ADDENDUM #3

Project Name: New Construction of:
West Whiteland Public Works Facility
121 Valley Creek Blvd.
Exton, PA 19341

Prepared for: West Whiteland Township
101 Commerce Drive
Exton, PA 19341

Date: August 25, 2023

P201 SCALE: 1/8" = 1'-0"

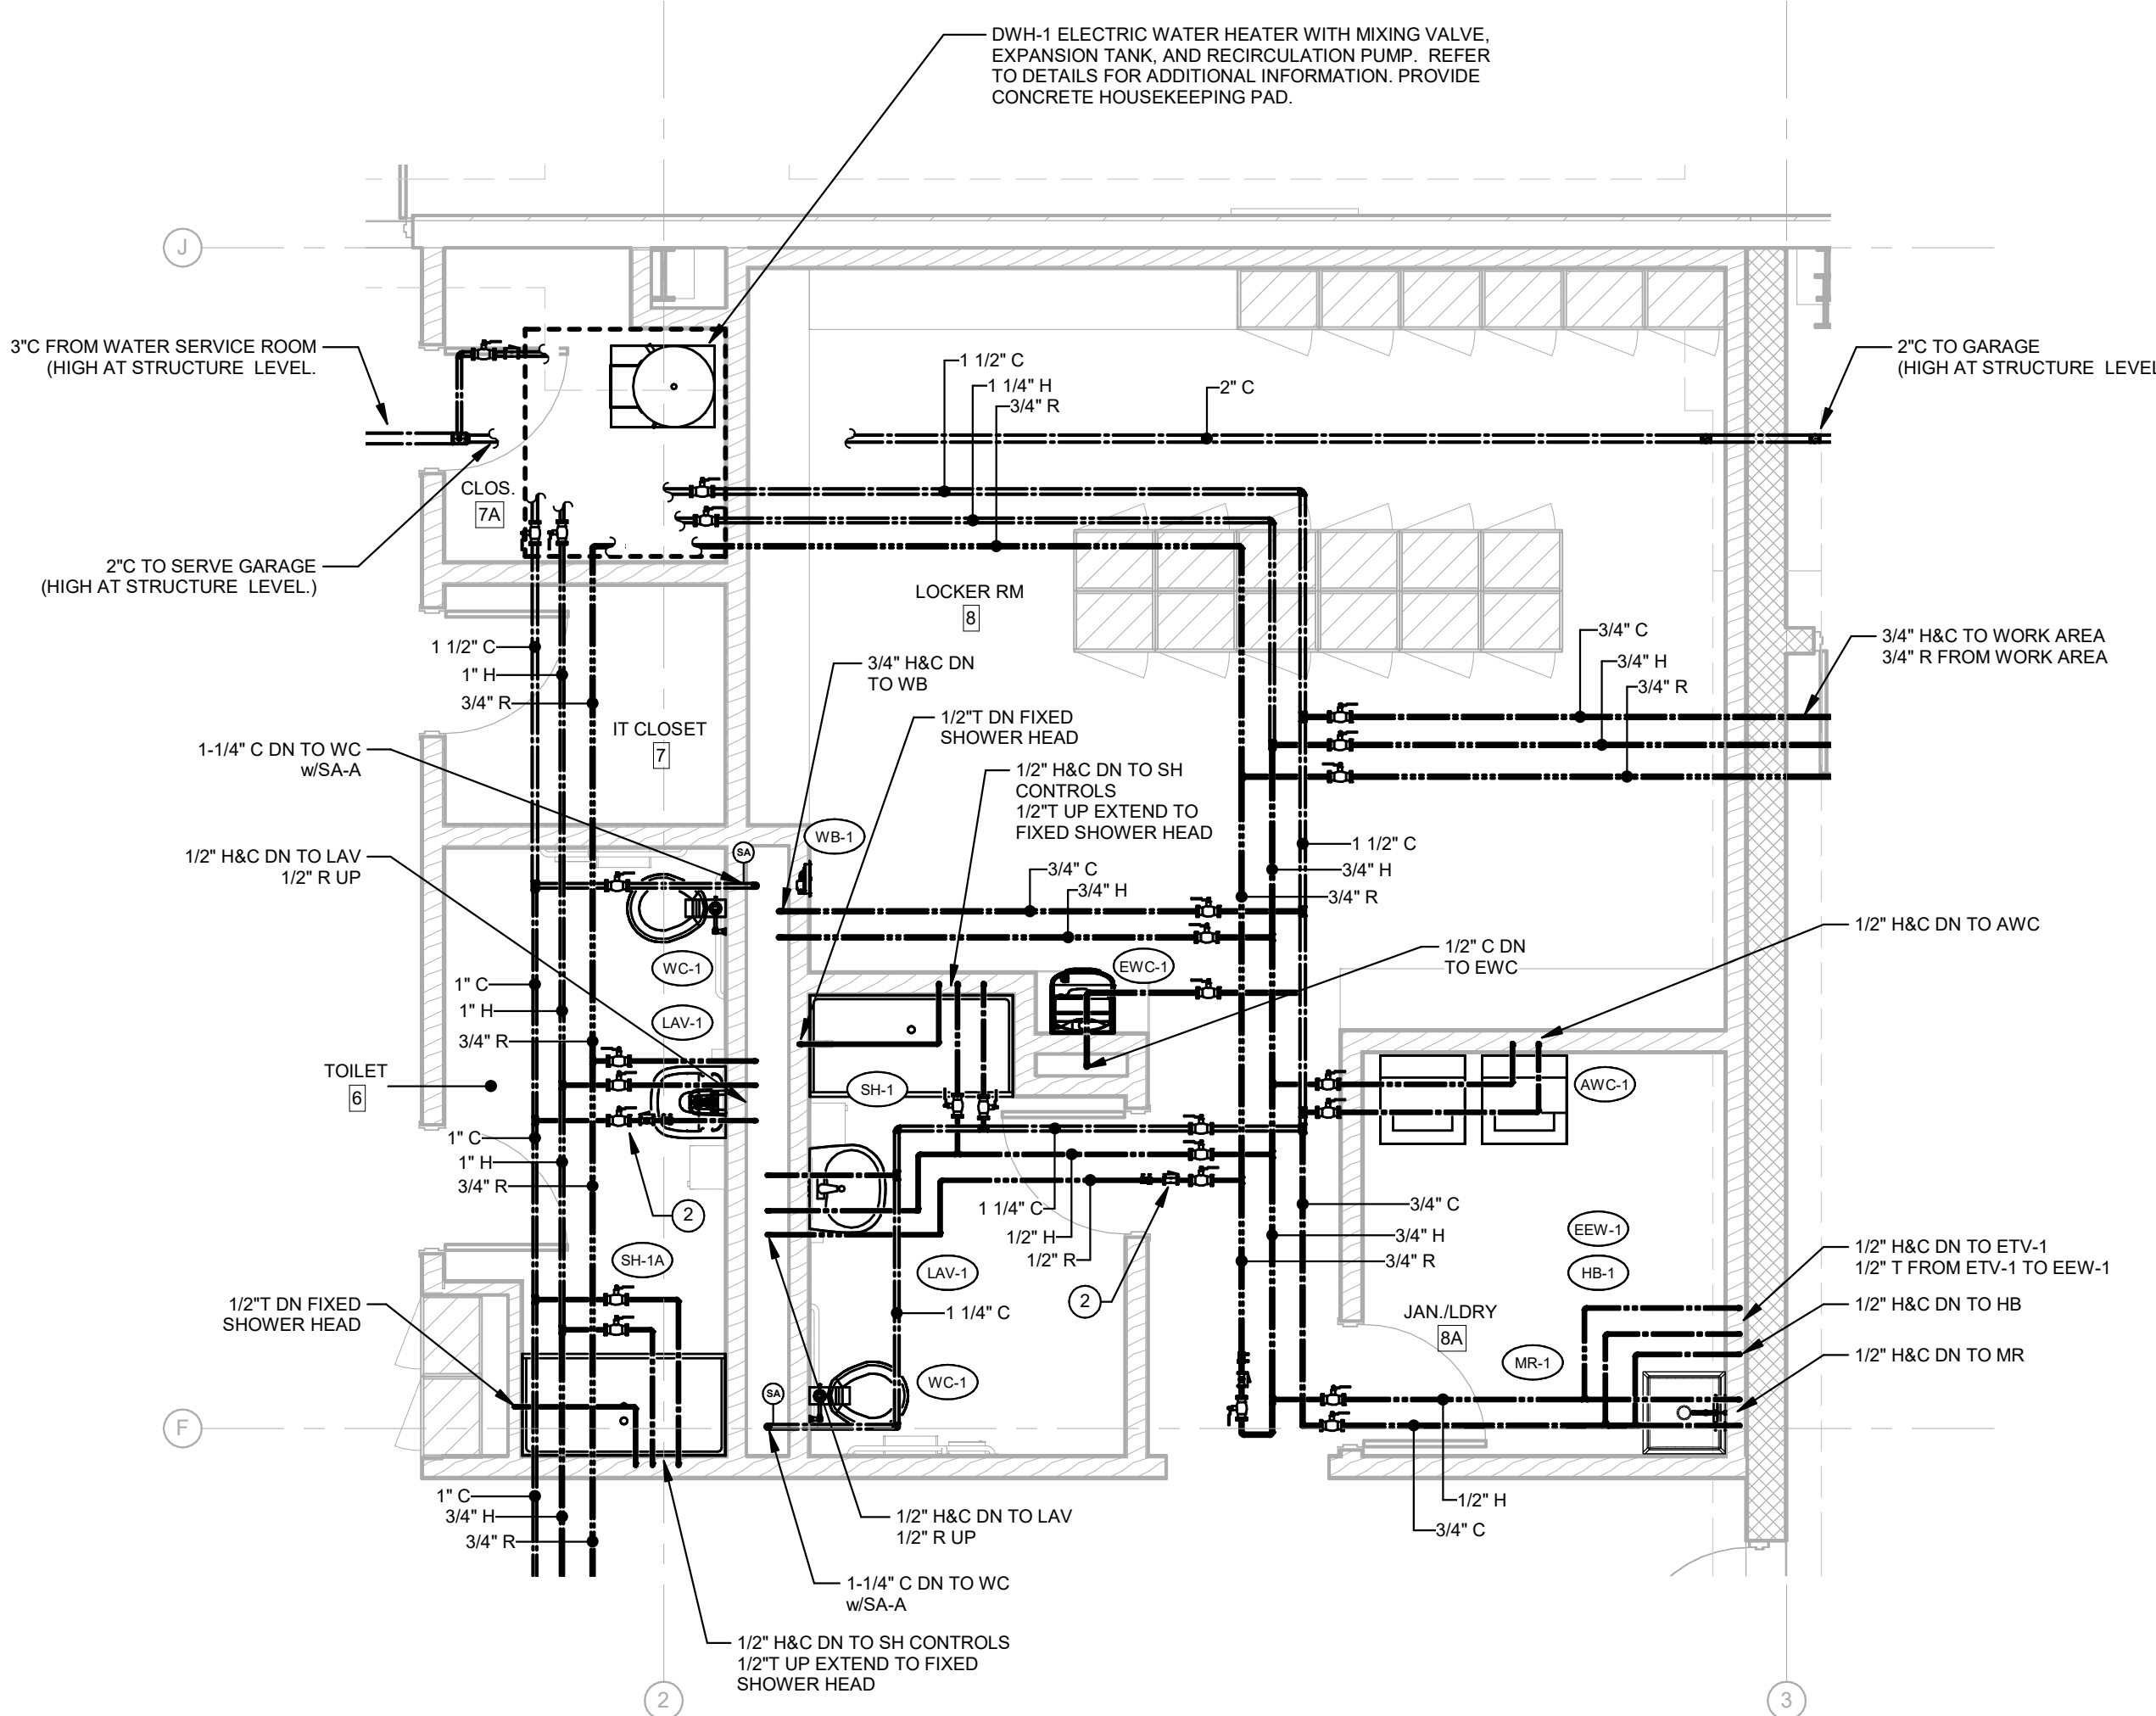
- 2.07 Drawing P201 FIRST FLOOR PLAN - BUILDING A - SUPPLY PIPING; **REPLACE** with attached revised drawing:
- 2.08 Drawing P202 FIRST FLOOR PLAN - BUILDING B - SUPPLY PIPING; **ADD** note to Brine tank as follows:
"P.C. SHALL RELOCATE AND INSTALL EXISTING BRINE TANK (OWNED BY WWT) FROM THE EXISTING TOWNSHIP MUNICIPAL COMPLEX.
CURRENT TANK LOCATION: MILLER WAY, EXTON, PA.
CONCRETE FOUNDATION PAD (BY G.C.)"
